# Council Communication

## October 20, 2015, Business Meeting

### Downtown Beautification Project Update

### ***Revised Landscape @ Pioneer Parking Lot***

**ORIGINAL DESIGN**

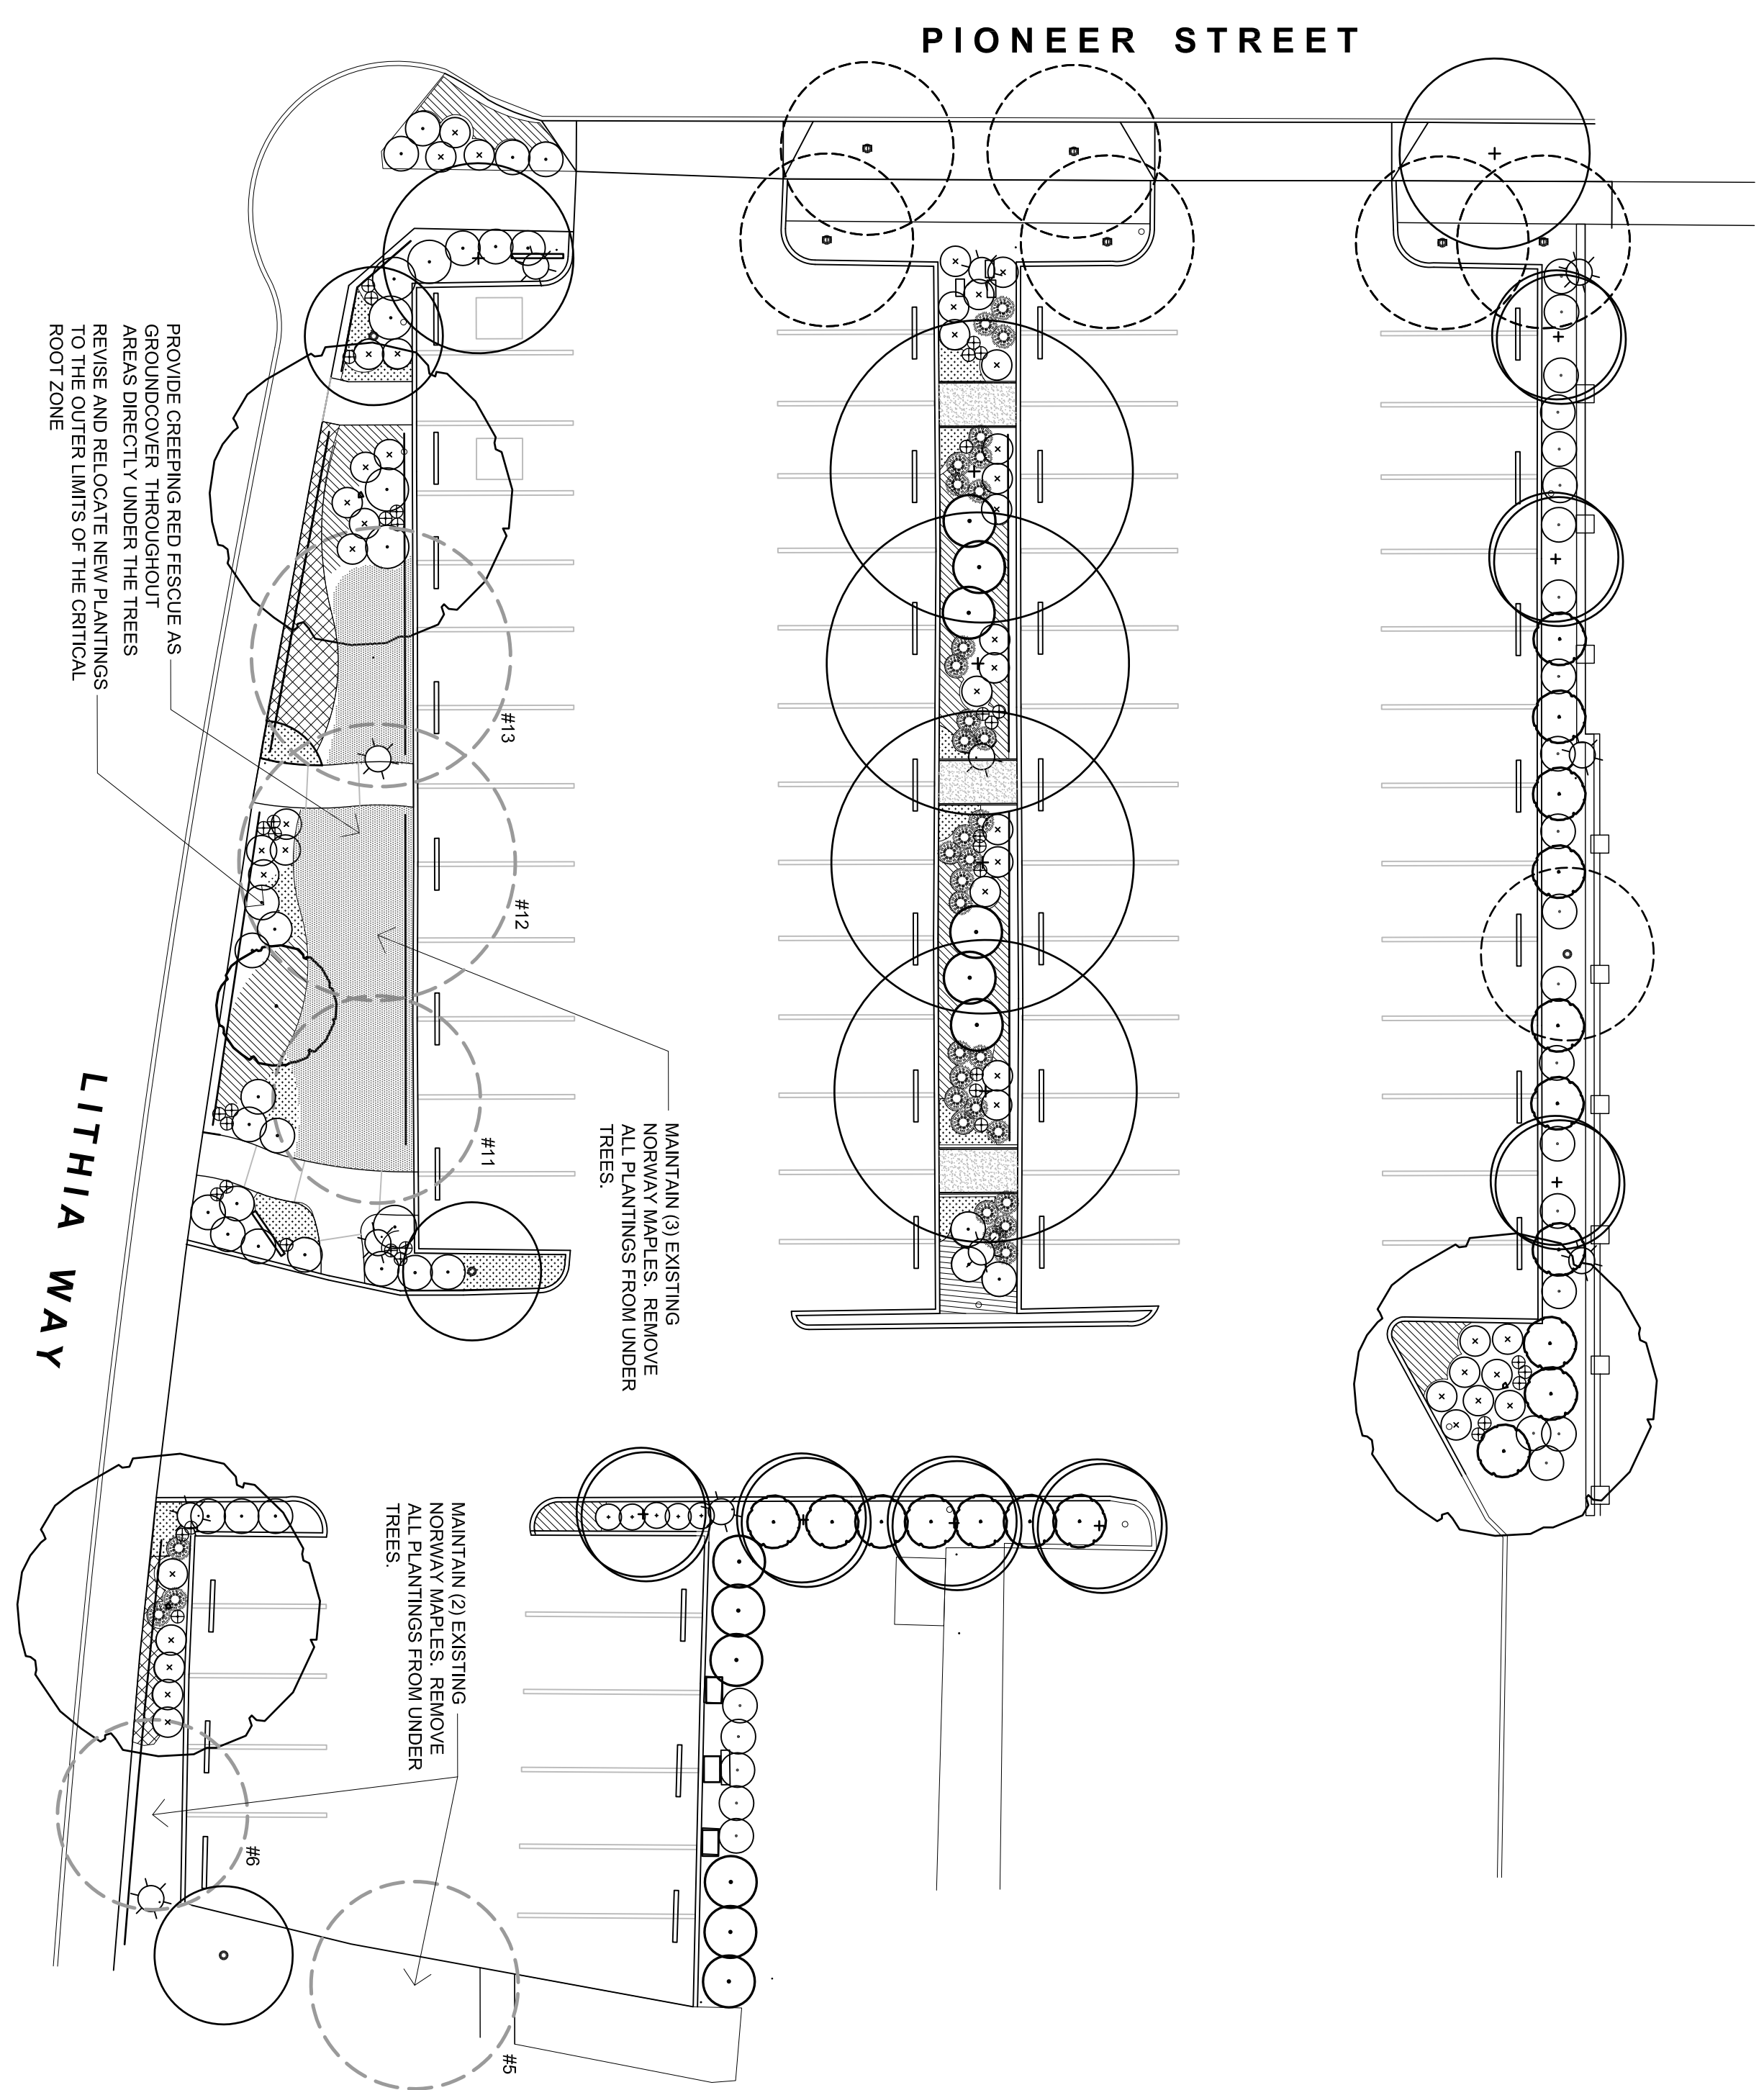
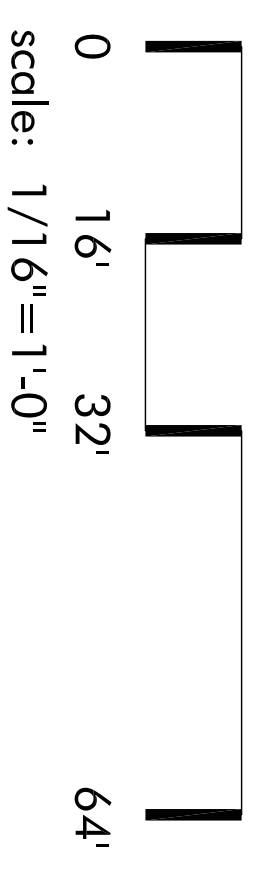
- The arborist's assessment of the existing Raywood Ash trees recommends the removal and replacement of all the trees of that species. This was reflected in the original design and in the current alternate design.

- The arborist's assessment of the existing Italian Cypress trees (*Trees #1-#4*) recommends the removal and replacement of all the trees of that species. This was reflected in the original design and in the current alternate design.

- The arborist's assessment of existing trees #5 and #6 notes these Norway Maples as healthy. The original design indicated these trees for removal. The alternate design includes these trees to be saved in the design.

- The arborist's assessment of existing trees #11 - #13 notes these Norway Maples as healthy. The original design indicated these trees for removal. The alternate design includes these trees to be saved in the design.

- The arborist's assessment of existing trees #14 - #16 notes these Chinese Pistache as healthy (*#16 is noted as being "slightly less healthy"*). The original design indicated these trees for removal. Our concern with these trees is in their adjacent proximity to the public sidewalk and that they are beginning to encroach into the canopy of Trees #11-#13. The location of Trees #14, #15, and #16 near the sidewalk could lead to sidewalk damage. Additionally, one of the

new paths connecting the parking lot with the sidewalk along Lithia would need to be located immediately adjacent to Tree #15. The alternate design does not include these trees due to these concerns.

- All other trees noted in the original design as being removed will stay as such. New shade trees will replace trees that are being removed as indicated on the original design.

- The original design indicated shrubs throughout all planting areas. In the alternate design, shrubs will, in general, be eliminated from under the trees to remain. The reason for not planting in the root zone of these trees is the potential for root damage when holes are dug for the new shrubs. Those areas where shrubs have been eliminated will be surfaced with bark mulch.

- In the areas where shrubs are being eliminated in the alternate design, irrigation will also be eliminated or reduced to further lessen the damage to existing tree roots.

- The new concrete path from the parking lot to the sidewalk nearest the Lithia driveway has been shifted closer to the driveway curb. This gets the sidewalk (and the soil disturbance it creates) further from the tree.

- The proposed public art base near the entry drive has been removed due to its location in Tree #11 critical root zone.

**REVISED CORNER DESIGN**

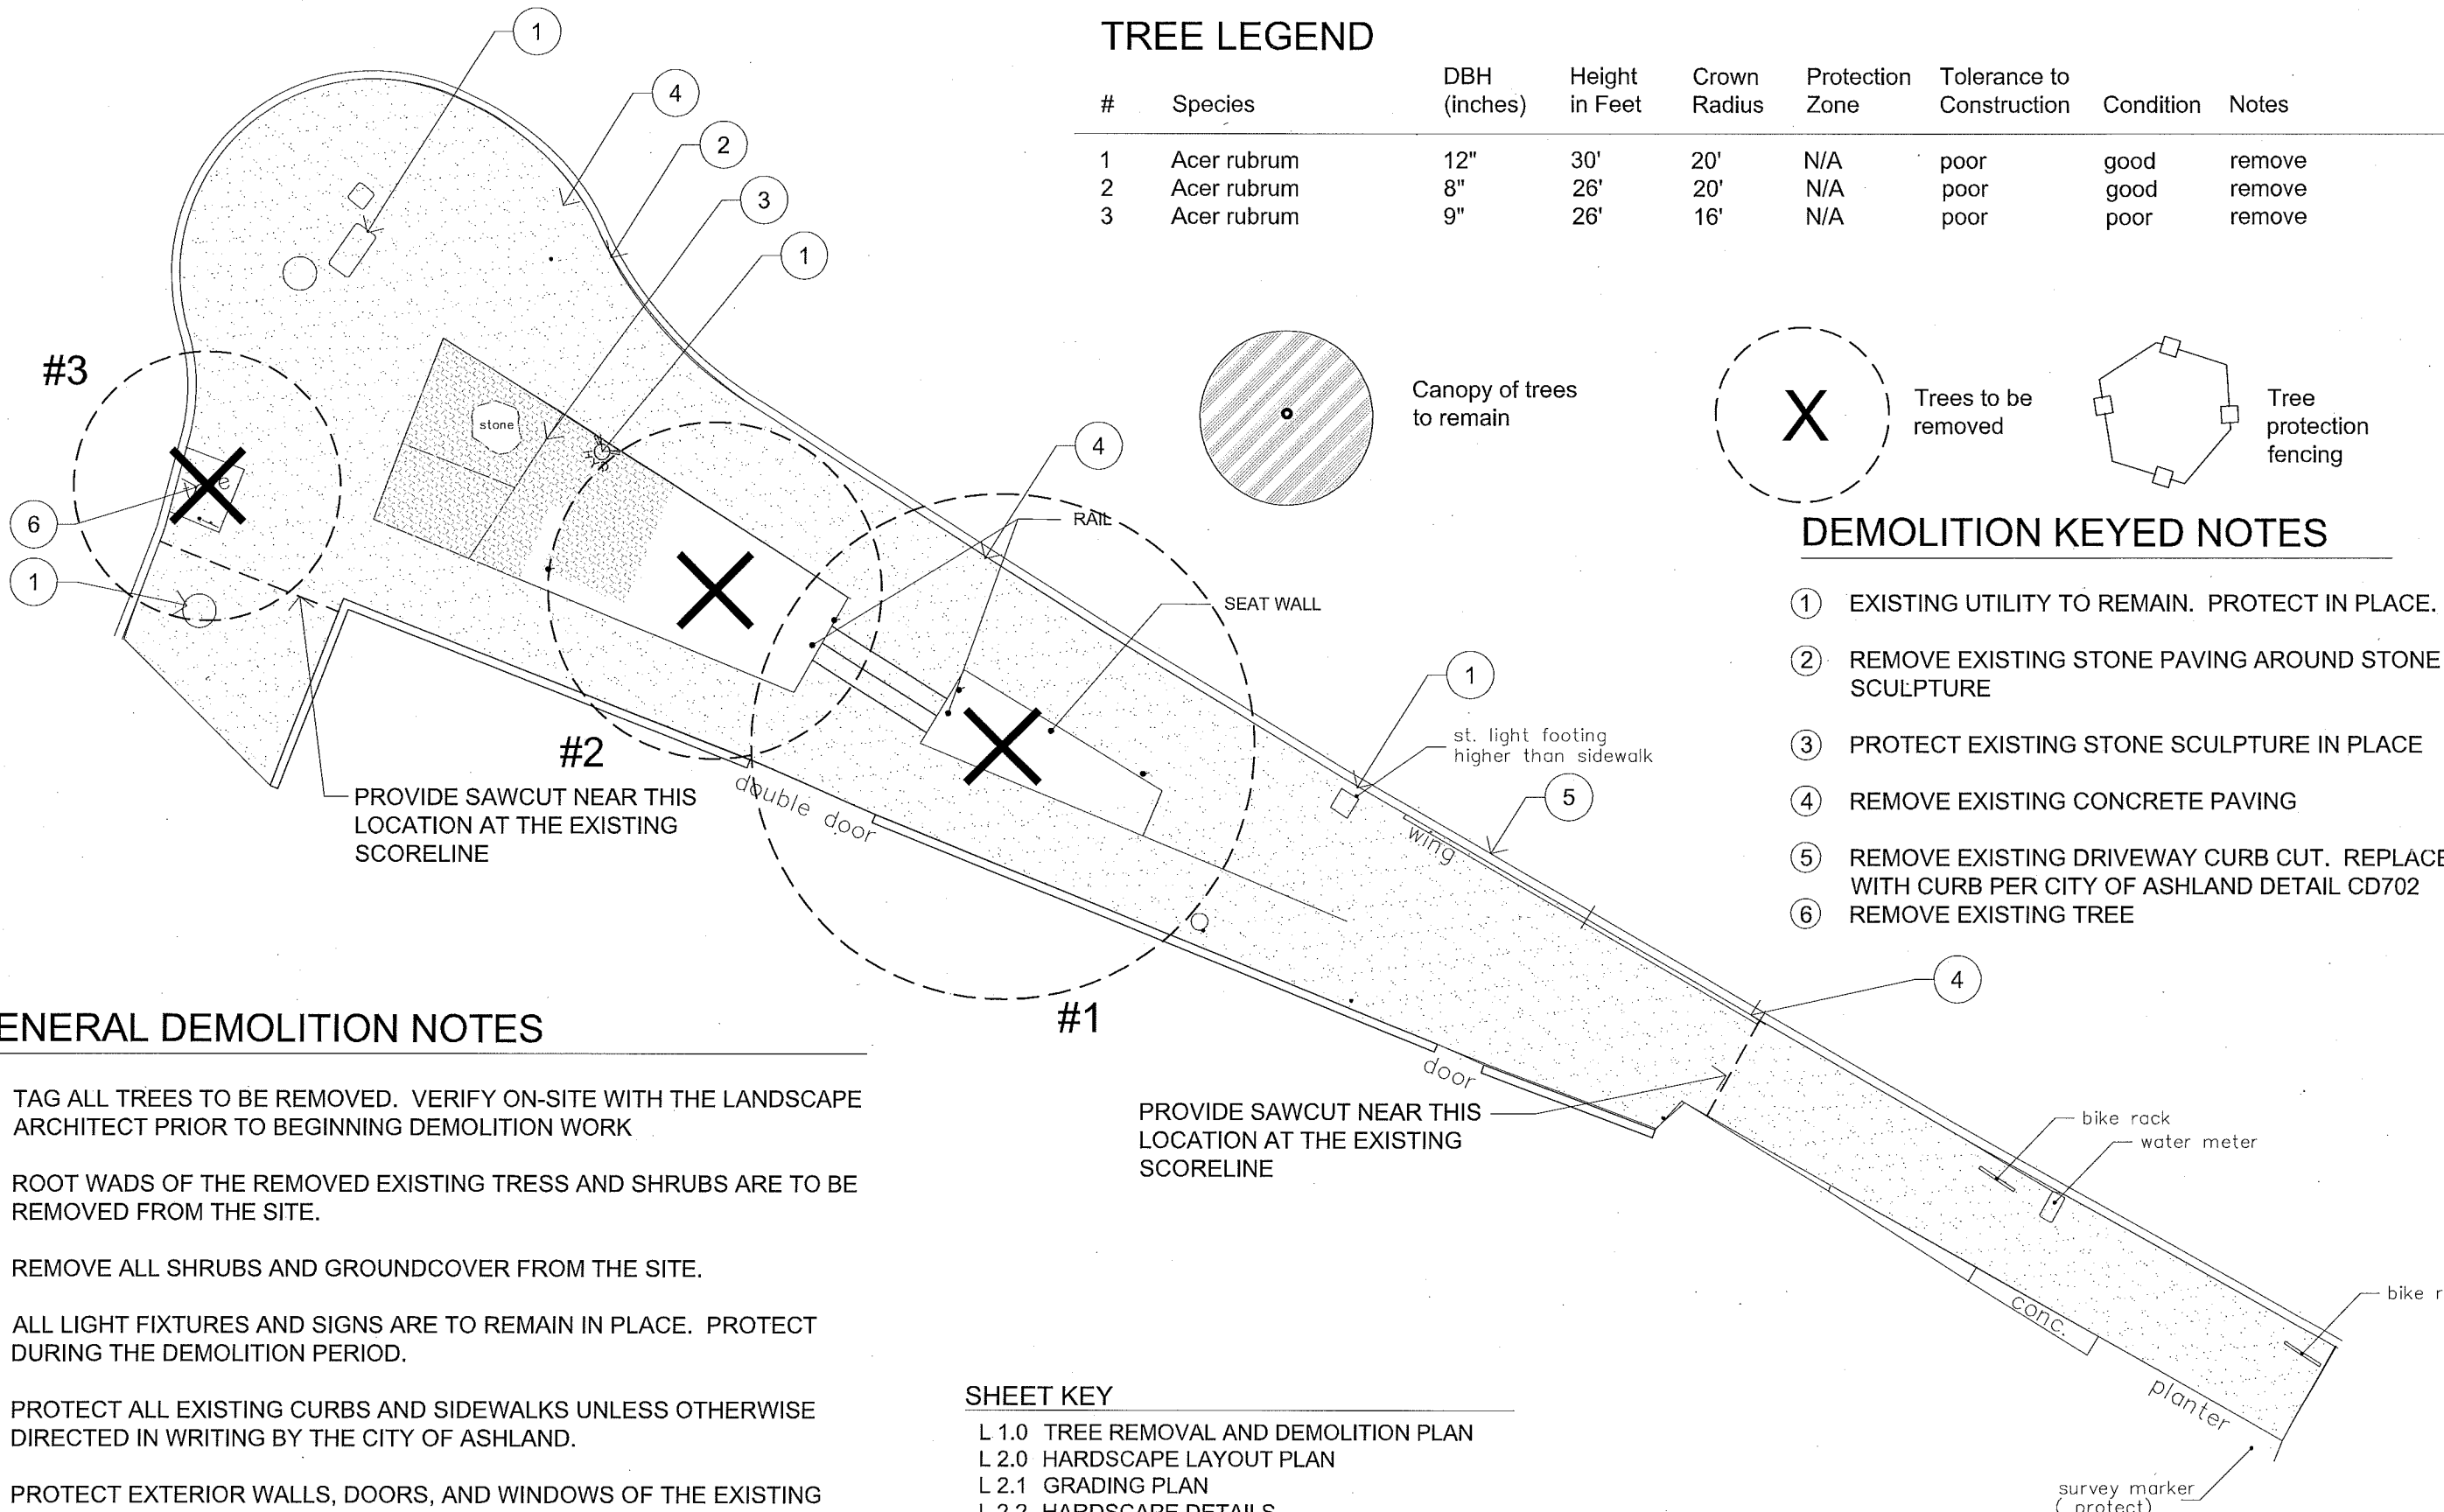
- The arborist’s assessment of the existing red maple tree east of the proposed steps (*Tree #1*) notes the tree as being “in a very restricted root zone and has likely reached its potential growth” and in “moderate health”. Currently the tree’s roots are beginning to impact the public sidewalk (sidewalk cracks and lifting) just east of the tree. This is viewed as a hazard to pedestrians and should be corrected by removal and replacement of the public and private sidewalks in that vicinity to provide a safe pedestrian zone. Based on our professional experience, the necessary construction in that area will have a negative impact to the tree that will ultimately expedite the tree’s decline. The alternate design reflects the original design with this tree being removed.

- The arborist’s assessment of Tree #2 (Red Maple tree) along Lithia Way notes the tree as being in good health although it points out that the soil appears compacted and devoid of organic materials. In its current state, the finish grade of the planter around the tree is elevated +/-6” above the adjacent public sidewalk. Per the original design, the tree was removed and the planting area lowered to the sidewalk grade. The alternate design retains the existing red maple (*Tree #2*) and the grade of the planter around the tree. We propose that an application of mycorrhizal inoculant be added to the soil. The existing modular block wall/curb adjacent to the sidewalk is removed and replaced with a poured in place concrete curb to retain the grade.

The area of the planter will be slightly decreased from the west to allow for a low seatwall to be installed near the public art display. The proposed steps and ramp adjacent to the building will be retained by a 6" wide poured in place concrete wall. To reduce the impacts to the tree's roots, the wall's footing will be designed so that any spread portion of the footing will be located underneath the paved areas.

- The area around the public art display will remain in permeable pavers although will be slightly smaller than the original design. In order to reduce impacts to the existing planter, the seatwall from the original design was relocated closer to the existing edge of the planter (to the west) and thus the reduction in the area of permeable pavers.
